V2500-D5 PROPULSION SYSTEMS SERVICE BULLETIN

This document transmits the Initial Issue of Service Bulletin EV2500-75-0087

V2500-ENG-75-0087

AIR – HP COMPRESSOR STAGE 7 SOLENOID VALVE – INTRODUCTION OF A REVISED MOUNTING
BRACKET ASSEMBLY AND SUPPORT BRACKETS

Location diagram
Fig 1

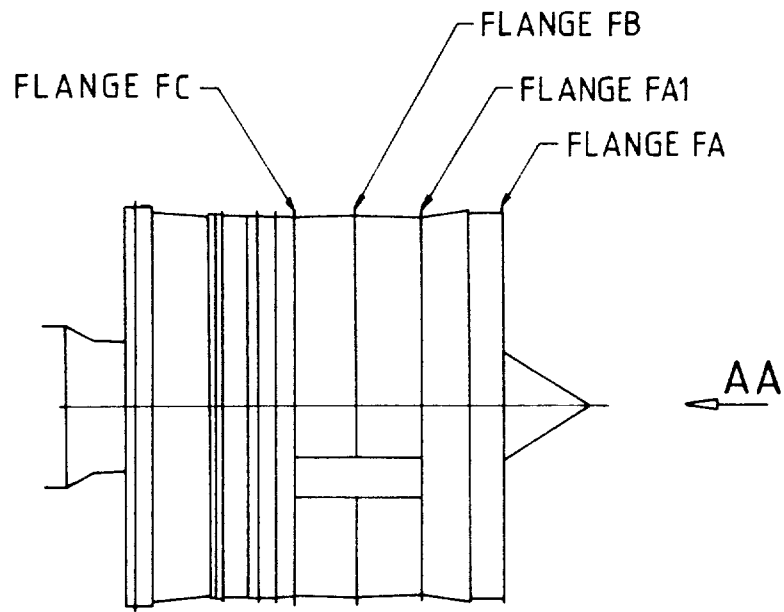
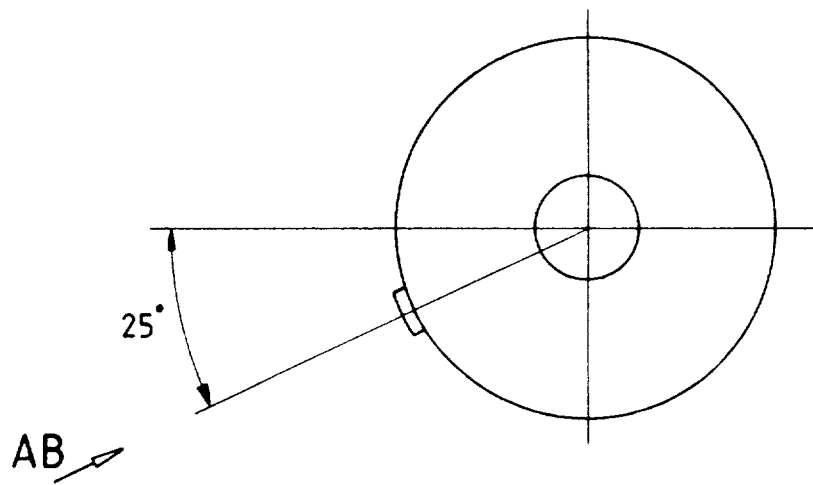
- (a) A revised bleed valve solenoid mounting bracket similar to the existing item except for the following:
- (i) The two holes that locate the solenoid bracket to the fan case at flange FC (see Fig 1) have been changed from plain holes to slotted holes.
 - (ii) The shape of the base of the bracket has been changed to maintain clearance with the fancase.
 - (iii) The five plunged holes located under each solenoid have been changed to plain holes.
- (b) A washer under the base of each nut on the slotted holes.
- (c) Two support brackets similar to the existing items except for the following:
- (i) The fancase locating holes have been moved to ensure the brackets sit nominally level.
 - (ii) The web feature has been removed.
 - (iii) Anchor nuts have been riveted to the brackets to attach the solenoid mounting bracket (in place of the deleted clip nuts in (d) below).

View of support bracket assembly
Fig 2

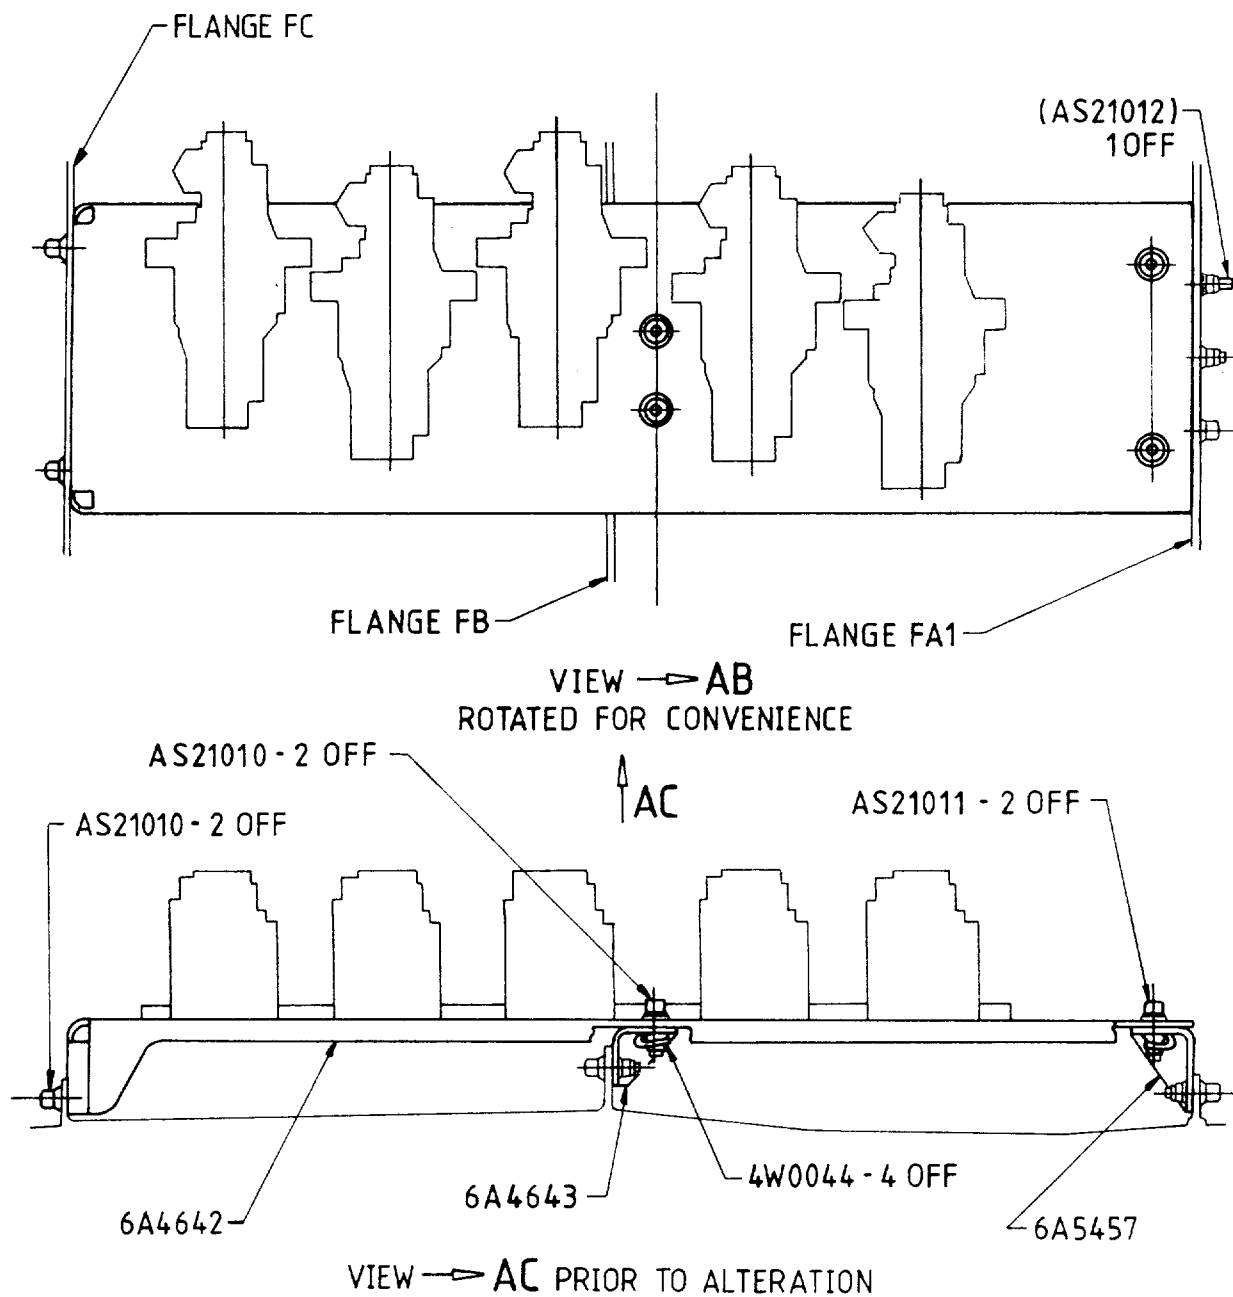
- (1) This Service Bulletin introduces a revised HP compressor stage 7 solenoid valve mounting bracket assembly to reduce the potential for misalignment and minimise residual stresses.

NOTE: To relieve any stresses during assembly, the brackets must be fastened to the fancase in the order that follows:

- (1) Tighten bracket 6A7640 to the fancase at flange FB. Use bolt AS21010 (2 off) and nut 4W0002 (2 off)
- (2) Tighten bracket 6A7639 to bracket 6A7640. Use bolt AS21012 (2 off) and washer 4W2622 (2 off)

- (3) Loosely assemble bracket 6A7639 to flange FC. Use bolt AS21011 (2 off), nut 4W0002 (2 off) and washer AS12944 (2 off). This sets raft alignment
- (4) Tighten bracket 6A7641 to bracket 6A7639. Use bolt AS21012 (2 off) and washer NAS1587-4C (2 off)

- (5) Tighten bracket 6A7641 to fancase at flange FA1. Use bolt AS21012 (1 off), bolt AS21011 (2 off) and nut 4W0002 (3 off)
- (6) Loosen by one quarter turn, both fasteners AS21012 (2 off) between bracket 6A7639 and bracket 6A7640

- (7) Tighten bracket 6A7639 to the fancase at flange FC
- (8) Loosen by one quarter turn, both fasteners AS21012 (2 off) between bracket 6A7639 and bracket 6A7641

- (9) Tighten bracket 6A7639 to bracket 6A7640
- (10) Tighten bracket 6A7639 to bracket 6A7641
